E3648A-04C

S E R V I C E N O T E

E3648A DC Power Supply

Metal Strap Kit for tightening loose bumper and for fitting rear lock link in side-by-side rack mounting

Figure 1: Top view 3mm gap observed between two different chassis designs

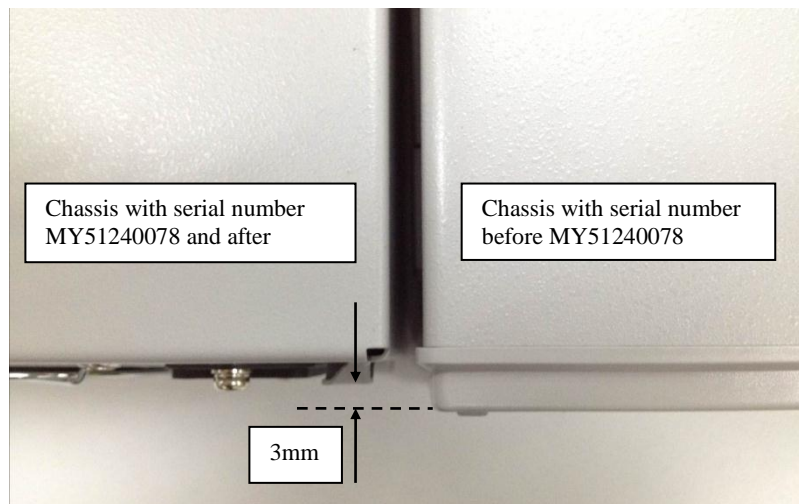
The chassis depth difference between the two designs is 3mm as shown in Table 1 and Figure 1 below.

Serial number range	Chassis depth
MY51240078 and after	345.2 mm
Before MY51240078	348.2 mm

Figure 2: Top view 3mm gap observed on rear lock link for side-by-side rack mounting

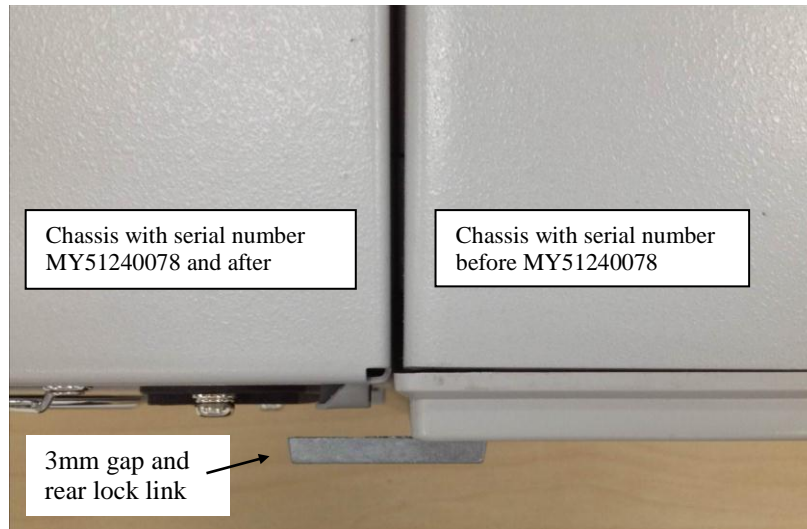
The 3 mm gap between the two different chassis may cause difficulties in securing them together using a rear lock link kit (part number 0050-2167) for side-by-side rack mounting as shown in Figure 2 below.

Use metal strap (part number E3631-07901), and stack the provided two metal straps together to form 3mm thickness and secure it with the provided screws on the rear lock link as shown in Figure 4 below.
